Briefing Note		DATE: 19/01/2026
ISSUE: 01		
PAGE: Page <b>1</b> of <b>1</b>		
No: BN205	Title: CF5228 & CF5229 Approved Screens	APPROVED: P. Brash

Description: **Approved Jointing Method - Strebord FD30 Doorsets & Side Screens**

Description: **Approved Jointing Method - Strebord FD60 Doorsets & Side Screens**

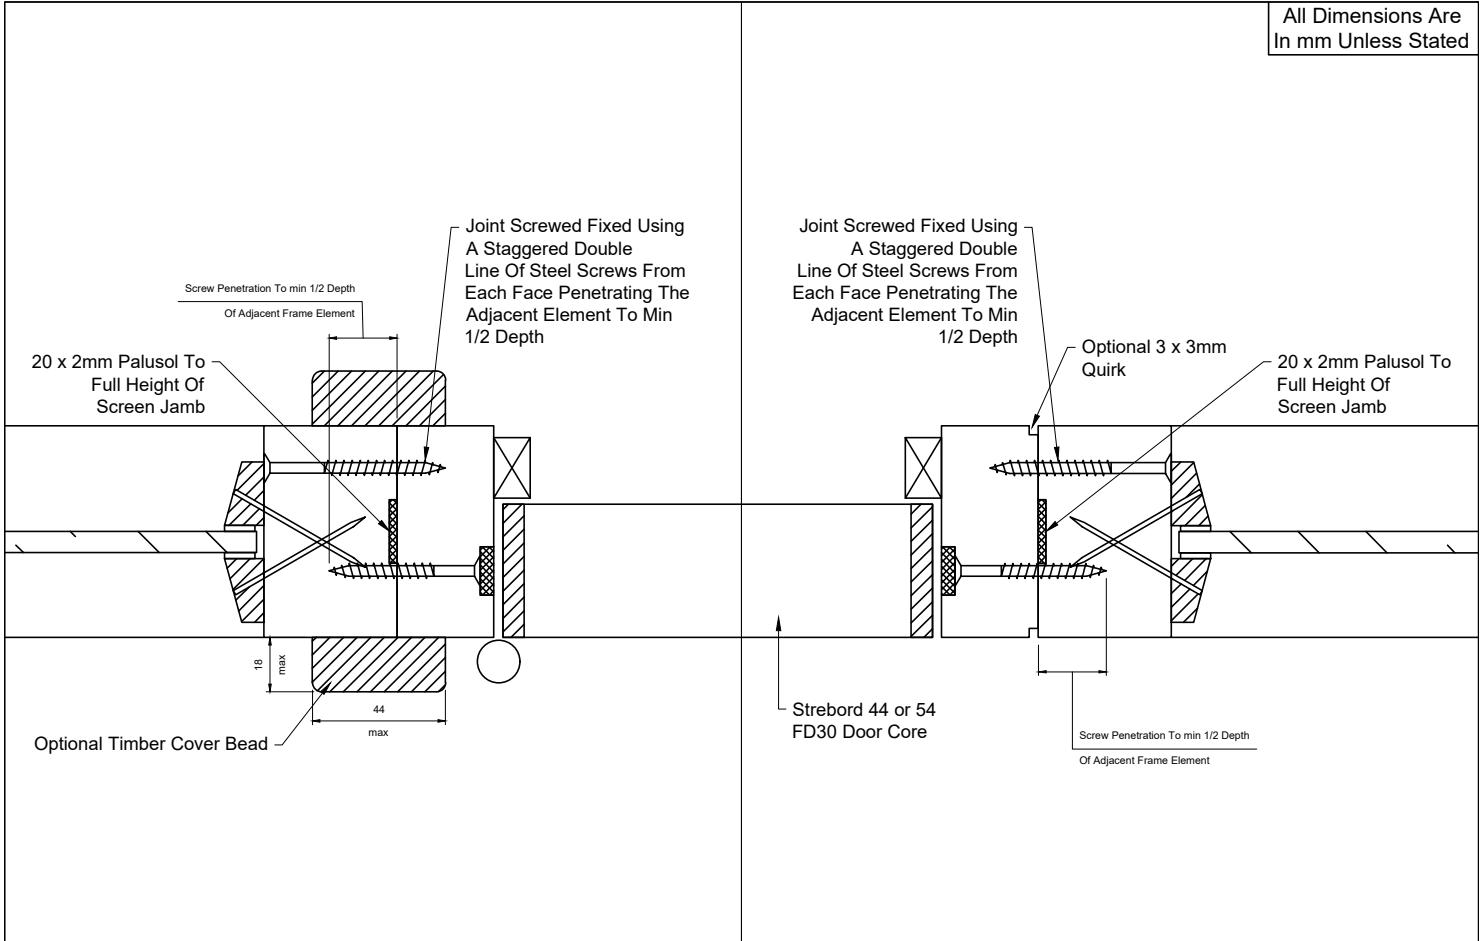
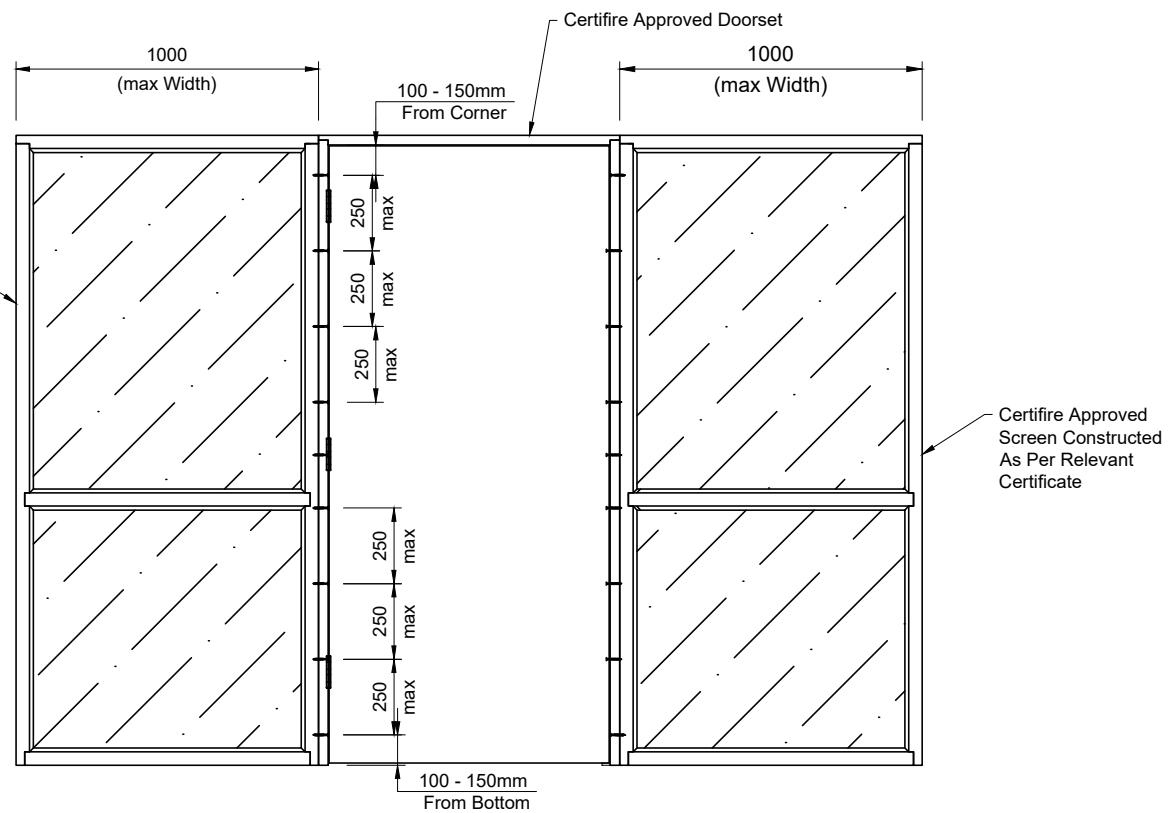
- Notable omissions from the Falcon certificates are side screens. They are **NOT** permitted under CF807 or CF808
- Doorpac has obtained dispensation for the inclusion of modular side screens in CF5228 & CF5229 on the following basis:

- Single acting single doorsets only
  - Side screens to be fitted into four-sided frames independent to the door frame
  - Side screens may incorporate any appropriate Certifire approved glazing system

- Maximum side screen width 1000mm per side
  - Maximum side screen height equal to that of the door assembly
  - Side screen & door frame section widths to be equal

- Back-to-back joints to be tightly butted together with no gaps
  - Joints can either be concealed with architrave or alternatively a maximum 3 x 3mm quirk may be incorporated

- Side screens to incorporate 1nr full height 20 x 2mm Palusol intumescent seal in the screen jamb abutting the door frame
  - Side screens to be mechanically fixed to the door frame using a staggered twin line of steel screws from each face penetrating the adjacent element by at least half depth of the component

- Fixings at maximum 150mm from top & bottom corners at maximum 250mm centres
  - Fanlights & over panels are **NOT** permitted in conjunction with side screens

- All new quotations including side screens should be completed to the specification noted above from week commencing 19<sup>th</sup> January 2020
- See drawings DP24059 Rev02 & DP24060 Rev02 attached
